Laurence and Associates, LLC
918 Government Street
Mobile, AL 36604

Subject: SCPA ZPMC Crane H-39-037 (#37) Vessel Impact Damage Assessment
LA, LLC Project Number 2405

ZPMC gantry drawings with requested new parts indicated.

PROJECT: South Carolina GOLI (various Cranes, USA)	DESIGN STAGE:	SCALE: 1:20
ITEM NAME: GANTRY 大车行走机构	DRAW NO: J227A04.00	PROJ:
ZPMC	DESIGN: []	APP: []
	DRWN: []	ASS: []
	CHK: []	SEI/CRME: []
	VER: []	WEIGHT: 4x375#

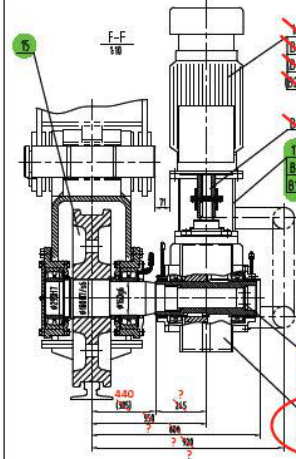
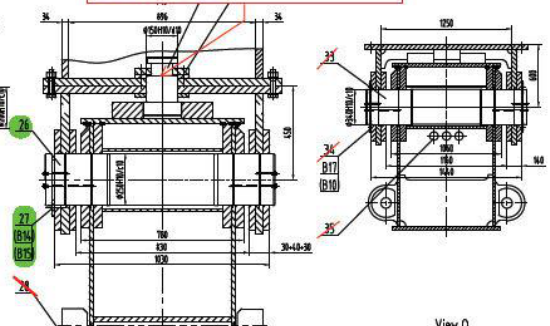
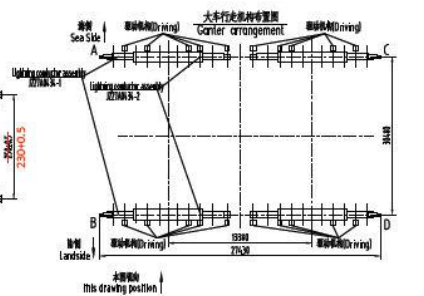
May need top connection plate - PENDING FURTHER INSPECTION - TBD

Pilot Boring on Motor Side

See note on drawing J227A0402

Change to new TNR500.B2.D2A00

To be checked

*Note - ZPMC Engineering to verify dimensions, component updates, and comments in this drawing.

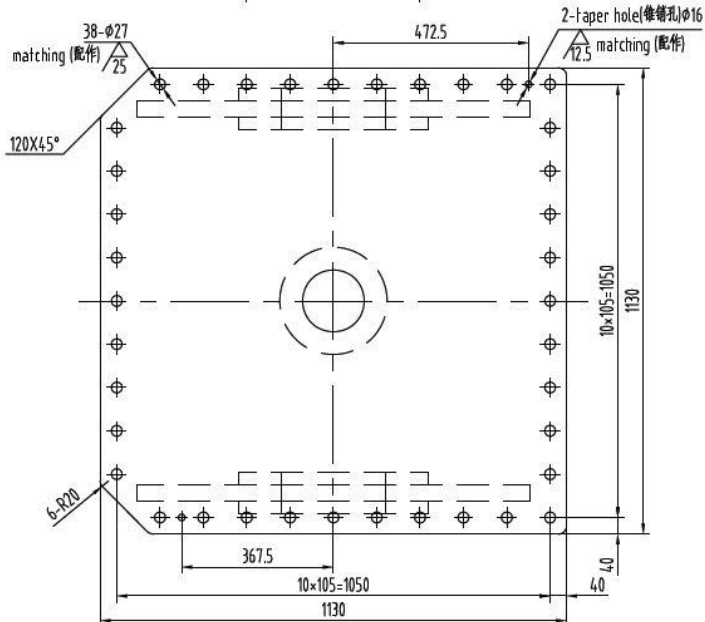
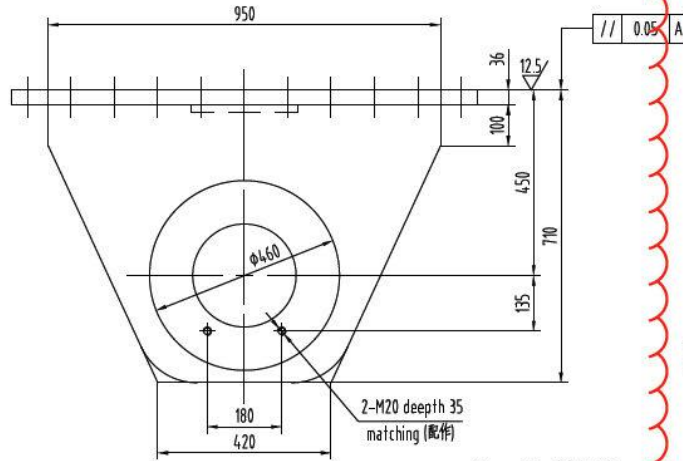
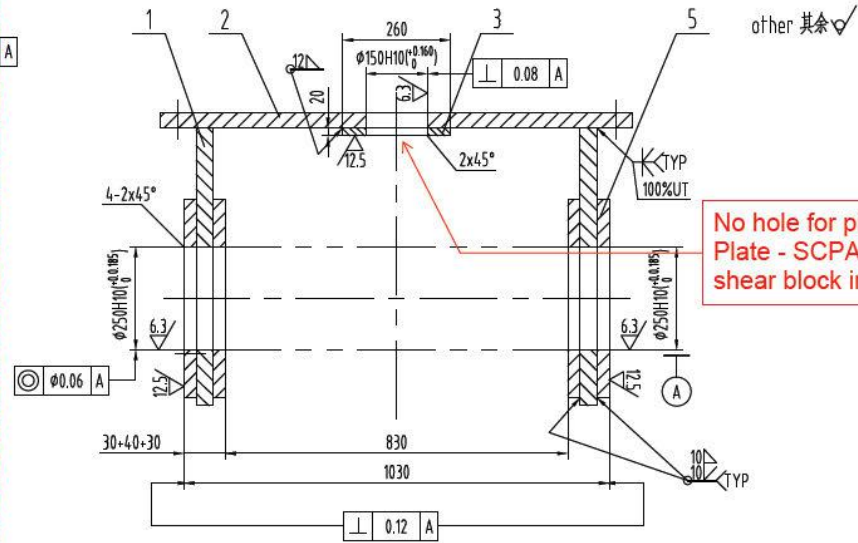
**DO NOT DRILL
BOLT HOLES - TBD**

No hole for pin - Solid Plate - SCPA will add shear block in US

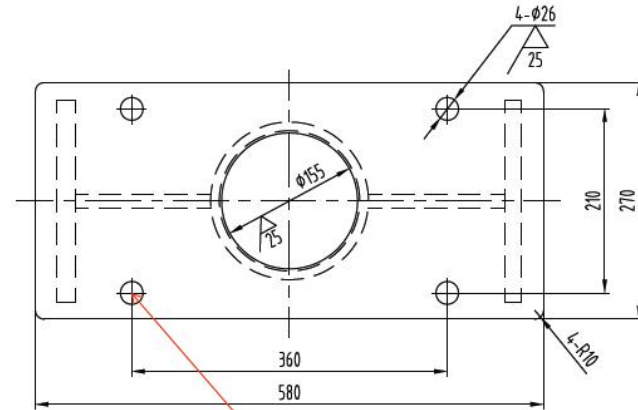
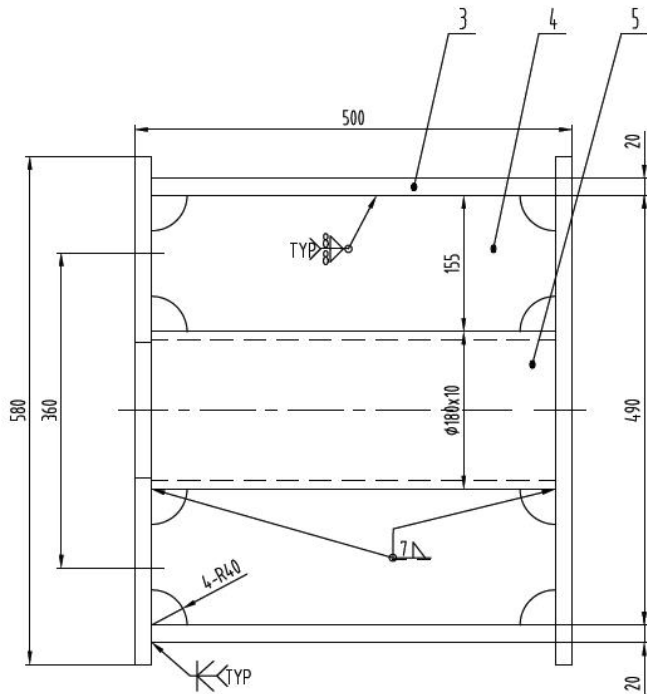
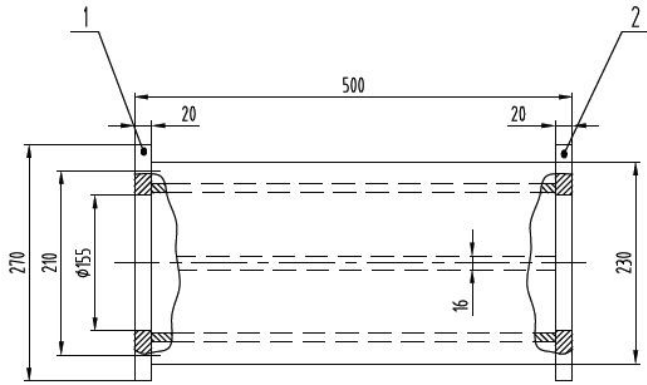
DON'T DRILL BOLT HOLES

NO.	SUB-NO. or STDD	NAME & SIZE	MTRL or STYLE	QTY/each	total	WEIGHT	NOTE
PROJECT:		DESIGN STAGE:		SCALE:		1:6	
ITEM NAME:		DRAW NO:		PROJ.			
Driving shaft assembly 主动轴轴装装配		J227A0413		Assembly(附件)			
ZPMC	DSGN	TRAC	APP.	SET/CRANE	20x735		
	DRAW	CHK	VER.	WEIGHT

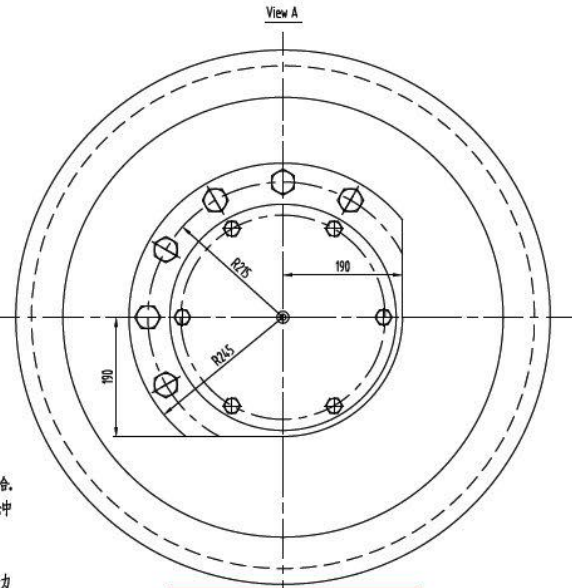
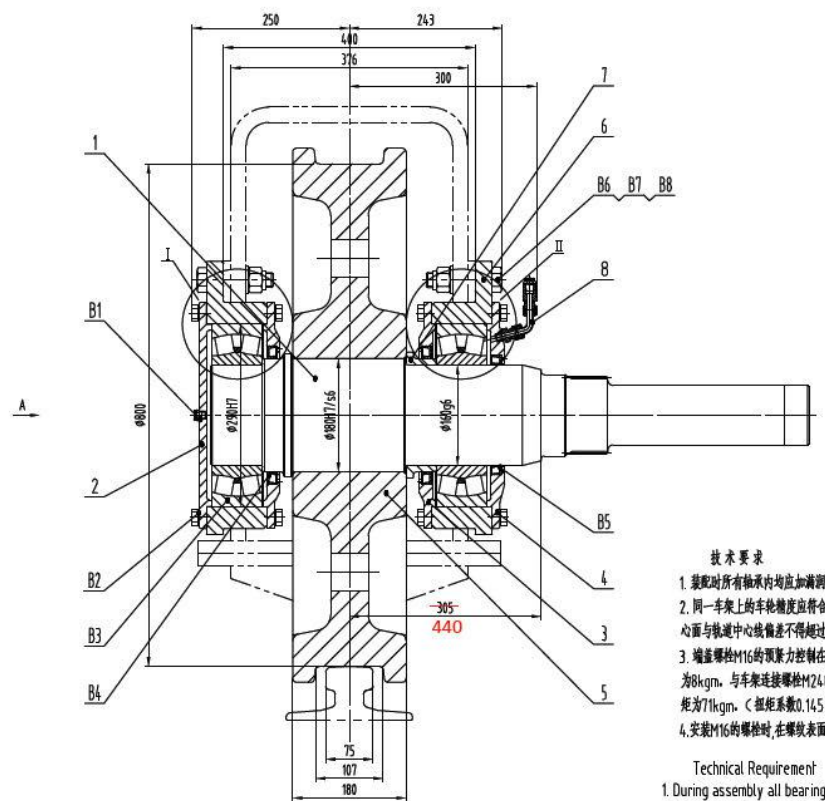
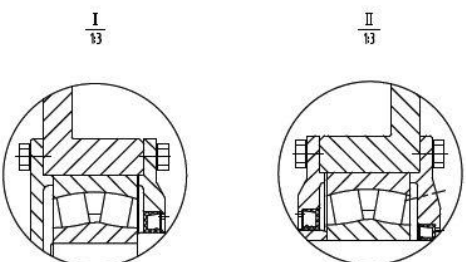
Modify per drawing
J227A041301 &
D21-114A-060401

*Note - ZPMC Engineering to verify dimensions, component updates, and comments in red.

NO.	SUB-NO. or STDD	NAME & SIZE	MTRL or STYLE	Q'TY/SET	SET*WEIGHT	SCALE
	J227A04.1301	Driving shaft(主动轴)	35CrMo	20	20x120	1:4
ZPMC	DRAW		TECH.		TRACE	
	CHCK		STDD		CHCK

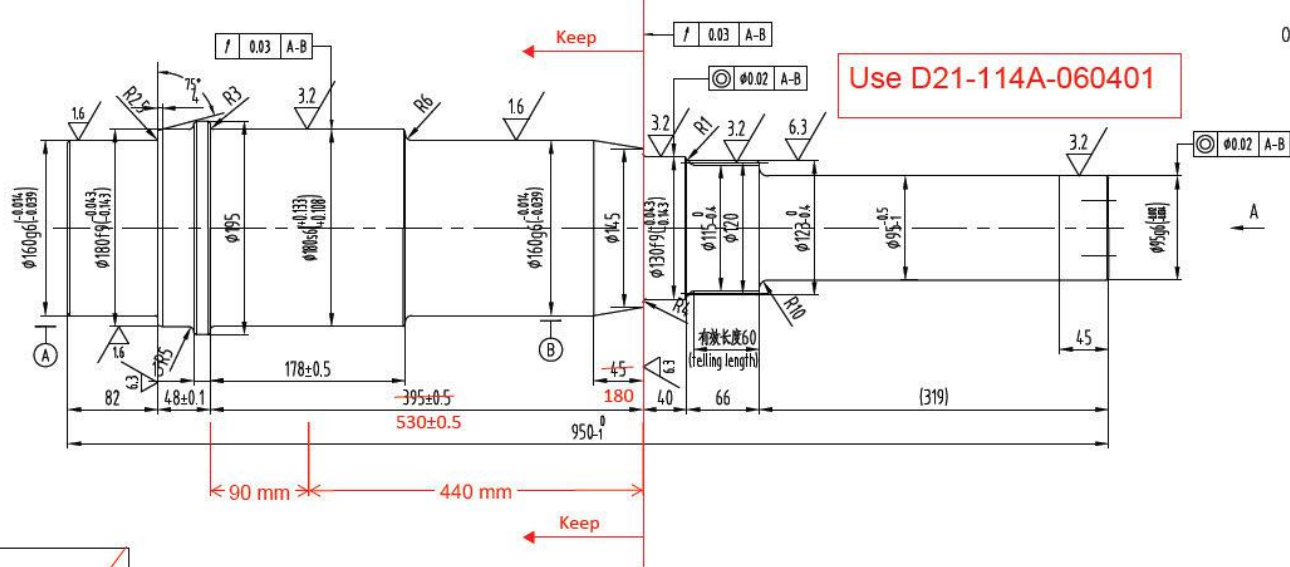
Use D21-114A-060401

*Note - ZPMC Engineering to verify dimensions, component updates, and comments in red.
